Re: Structural Observation — 106 Micahs Way North, Spring Lake, NC 28390

At your request, on January 6, 2025 we performed a review of the structural plan proposed by *Tar Heel Basement Systems* for the first-floor framing stabilization work at the Spring Lake residence noted above. The structure is a conventionally framed, detached, single family residence with raised first floor framing over a pier/girder foundation system with perimeter masonry foundation walls (see *picture 1*).

First Floor Framing Stabilization

Picture 2 – Example of haphazard support

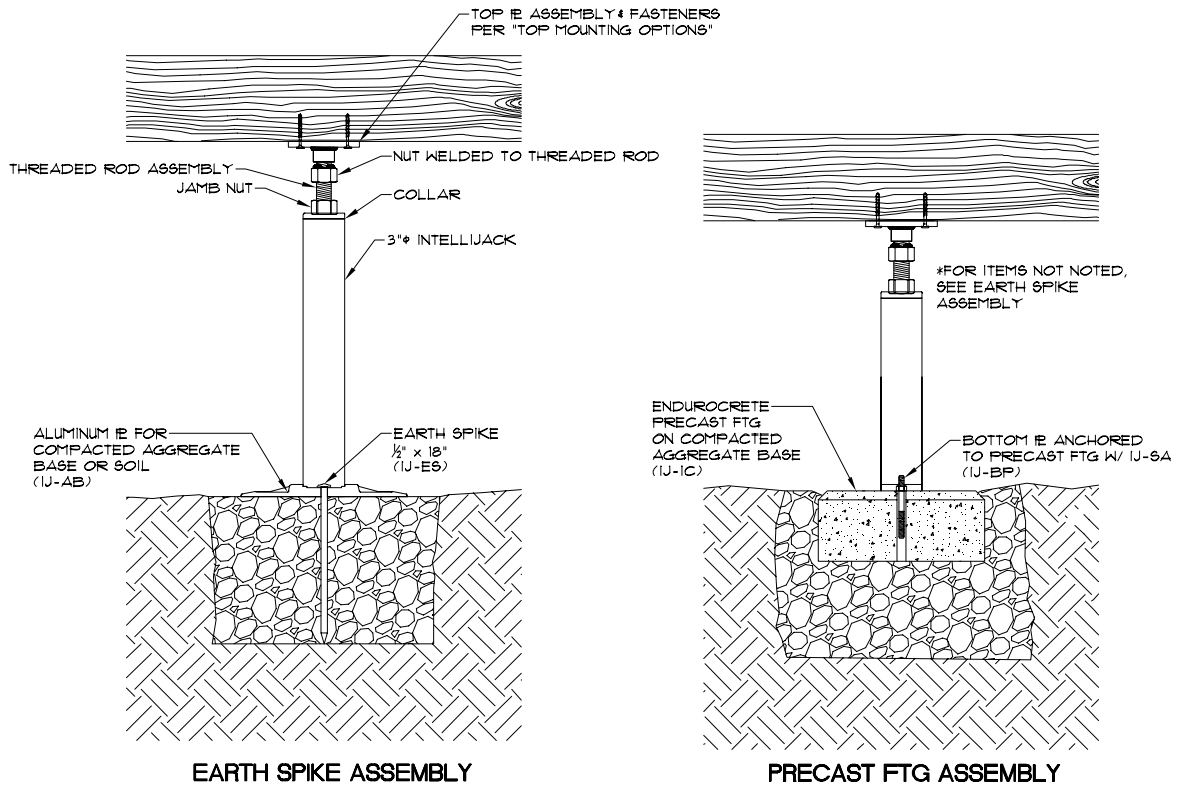
- Between the 2nd and 3rd girder lines from the right, a supplemental dropped girder had been installed. (*see picture 2*).
 - This girder did not appear to be installed to prevent rotation of the girder or appear to have a proper foundation element.

- 1) Reinforce the second girder line from the right foundation wall using an IntelliJack support on a well-compacted 18"x18"x18" gravel footing. Jacks should be located within the middle 1/3 of each girder span and at the approximate locations shown in the attached repair schematic (*see detail 1*).
- 2) Replace the above noted supplemental girder with a new S4x7.7 dropped girder within the middle 1/3 of the joist span. Support the replacement girder using IntelliJack supports on well-compacted 18"x18"x18" gravel footings spaced no more than 6'-6" apart (*see detail 1*).

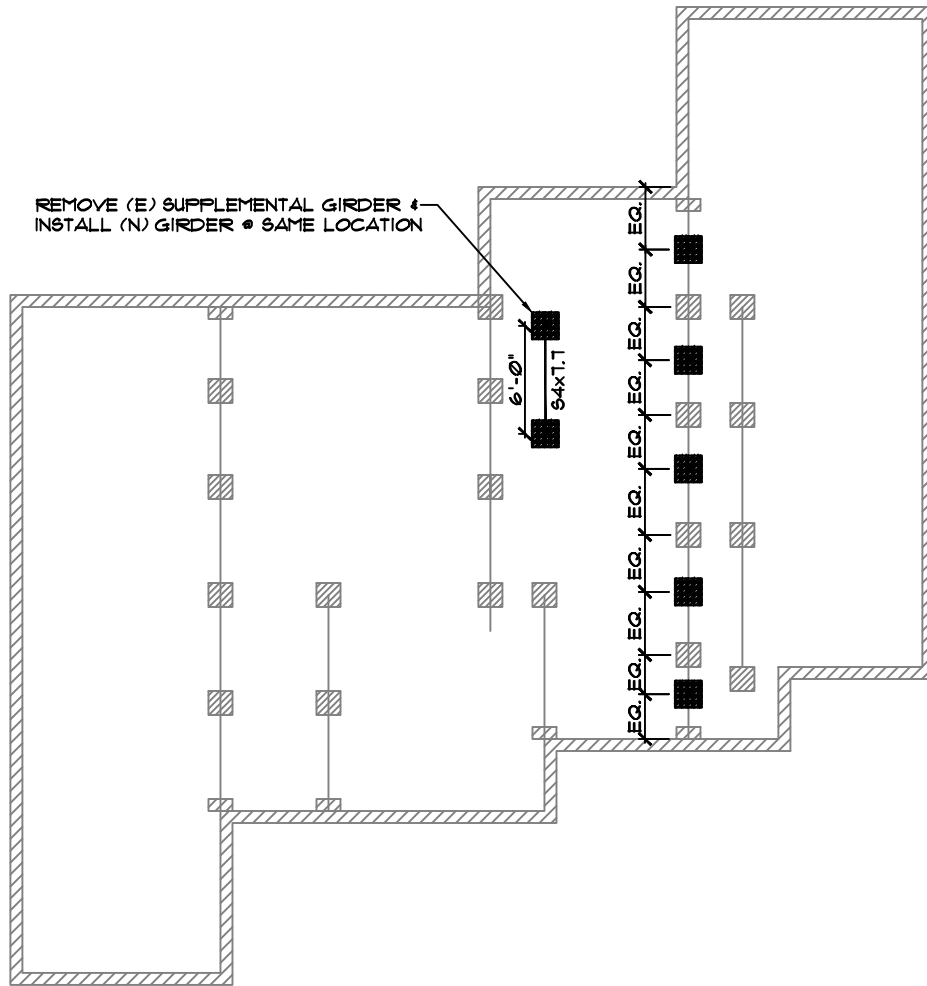
We recommend the following work be performed by a qualified general contractor (*see repair schematic at end of this report*):
